Huntlee – Stage 1 MP10_0137 Modification 20 – Response to Submissions

Ethos Urban has prepared this letter for Huntlee Pty Ltd regarding the section 4.55(2) Modification Application (MOD 20) to Project Approval MP10_0137, relating to the Huntlee New Town, Branxton. The purpose of this letter is to provide a response to a Request for Further Information (RFI) received on 19 September 2022 from the Department of Planning and Environment (DPE). The RFI requests a response to a single public submission received on the amended application, submitted as part of a previous Response to Submissions (RTS) and two previous RFI responses. It is noted that the RFS have been requested for comment on the RTS and previous RFI responses however no comments have been received.

PROPOSED MOD 20 CIVIL WORKS

MC17 EXISTING LOT CONNECTION

Figure 2 Potential road and pedestrian connectivity to Lot 34

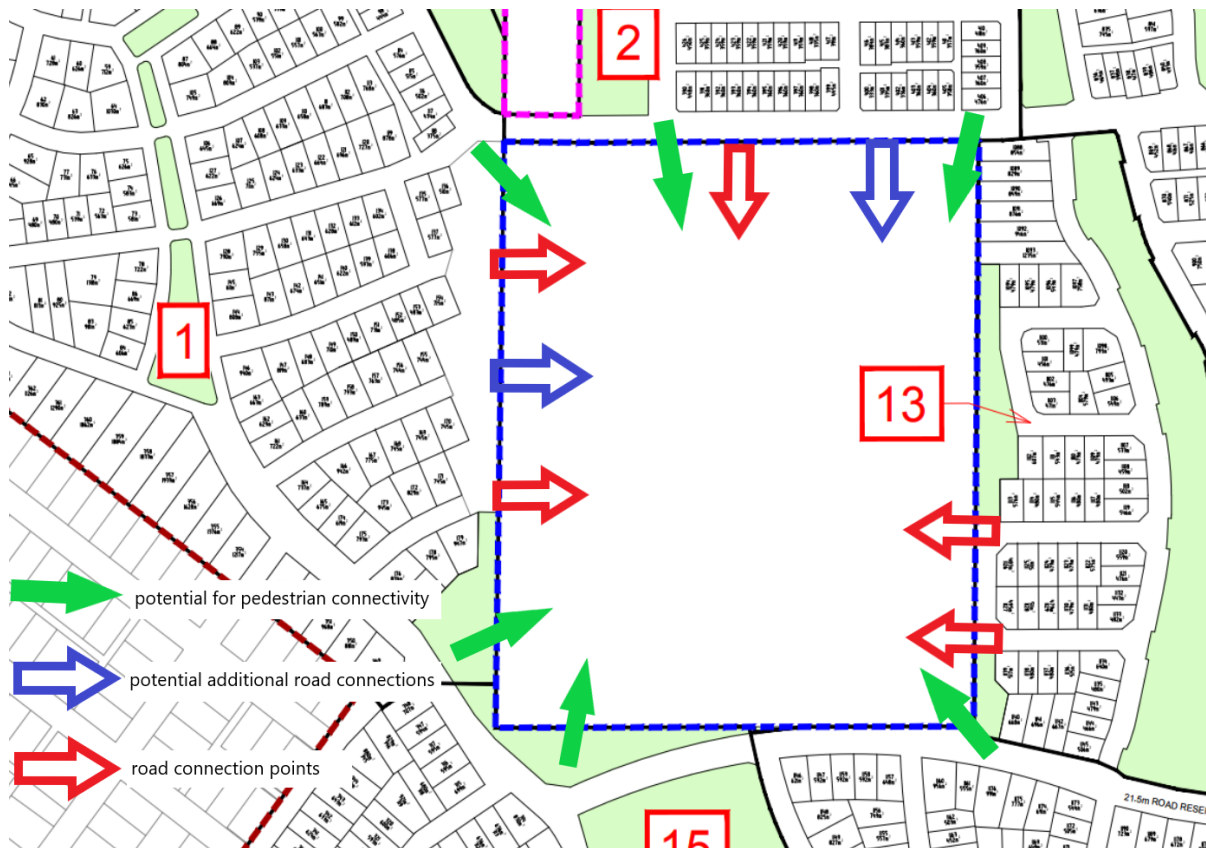
Proposed road MC43 is separated by a detention dam, which prevents access to the subject lot boundary.

Mod 20 does not include any remedies to ensure connectivity along the western boundary of Lot 34, as required by the Huntlee DCP.

Huntlee has been communicating with various parties looking at potentially developing Lot 34, and notably no parties have proceeded to preparing any detailed plans for an actual development application submission. Based on what Huntlee is aware of to date, the latest plans provided five road connections to the surrounding road network, as per the red arrows shown below in **Figure 2**.

It is noted that in addition to those five access locations, there would be at least two more additional road connections that would be achievable which are marked as blue arrows in **Figure 2**, providing a potential seven road access locations for a potential maximum dwelling yield of 123 as noted in the original rezoning.

There are also additional other potential points of access for pedestrian connectivity to roads and open space areas surrounding Lot 34 in addition to the road network as shown by the green arrows **Figure 2**. The below illustrates there is significant road and pedestrian connectivity achievable for Lot 34 based on the proposed Modification 20 layout and considering the potential yield on Lot 34.

Access to Lot 34 in this location is still provided by MC42 to the south. Further, access is available from Triton Boulevard to the north. The detention and water quality basin is required in order to achieve the required water quality outcomes and ensure no additional flooding downstream, and has been located in areas at the top of creek lines which extend through the eastern side of Lot 34. Numerous other road and pedestrian connection points are possible as illustrated in **Figure 2**.

As illustrated in **Figure 2**, the existing road network on the western boundary of Lot 34 already has three existing public road access locations that can easily be extended. As mentioned above, there is expected to be limited development potential on the western side of Lot 34 due to the location of the north-south riparian corridor.

Figure 3 MC42 preliminary road design and Lot 34 level review

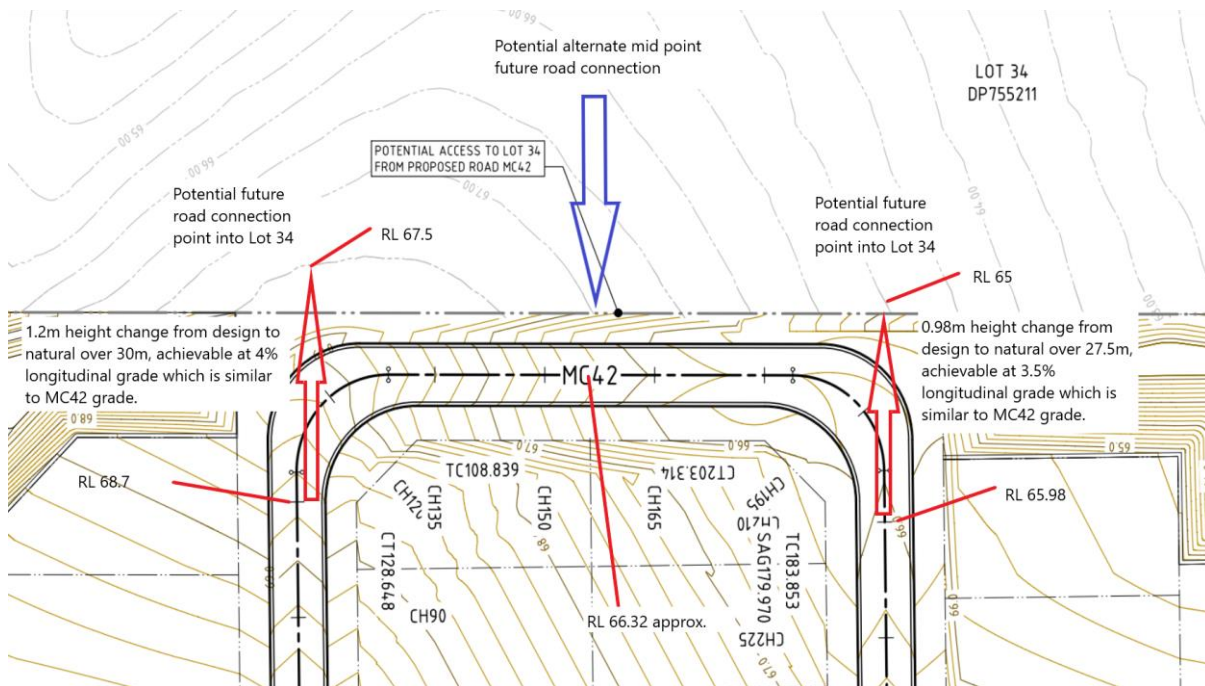
Proposed road MC42 indicates potential access to Lot 34, however the parts of that road will be over 1 metre below the adjoining surface of Lot 34.

It is noted there are no design plans for Lot 34, and that this interface would need to be resolved as part of any design proposed on Lot 34.

The topography of Lot 34 and adjacent Huntlee owned land is generally falling to the west at grades of around 4% to 6%. Huntlee has considered this a potential connection point for roads into Lot 34 and it would be expected that the two parallel east-west sections of MC42 would be extended to the west into Lot 34 to continue the development cell.

The preliminary road design levels and Lot 34 levels are shown in **Figure 3** and the extension of longitudinal grades into Lot 34 is achievable with grades similar to that of the natural fall of the land.

Should the future developer of Lot 34 prefer a single road connection at the midpoint (blue arrow in **Figure 3**), the height difference between the preliminary road design and adjacent Lot 34 is approximately 700mm - this amount of excavation for road construction is not uncommon or significant and therefore would not prevent a potential future connection. The road levels in this area are designed such that stormwater can drain to the adjacent basins rather than through Lot 34 and are therefore largely fixed.

Figure 4 Western access into Lot 34 at existing driveway location

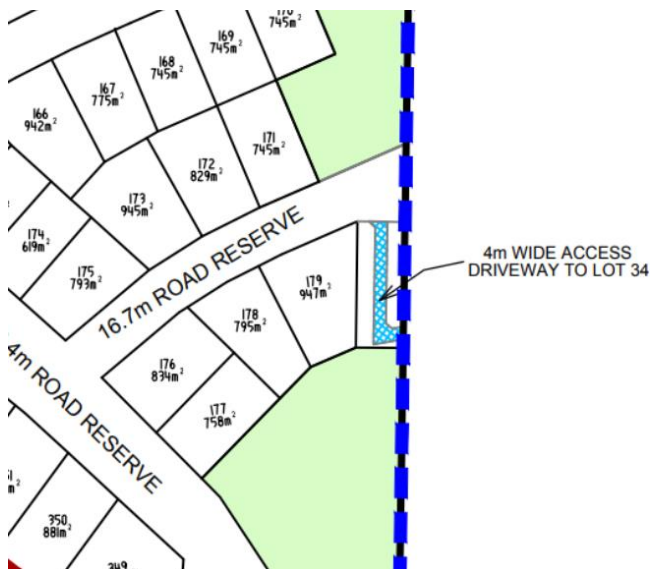
The proposed new road extending east off Abberton Parkway at about chainage 67 (Inset 'A' sheet 13) does not include any details of how vehicles will manoeuvre at the end of that road. Inset 'A' M20-C03.13 indicates 'new public access point for existing Lot 43'. Is this intended to be a public road for access to existing Lot 34? If the intention is for this road to terminate at the western side boundary of Lot 34, then more details are required, specifically involving the boundary and surface levels on Lot 34.

The overall Modification 20 base plan submitted as part of the original application confirms that this new road extension is to be dedicated as public road for future access to development within Lot 34, as well as including provision for short term access to the existing residence driveway, extract below in **Figure 4**.
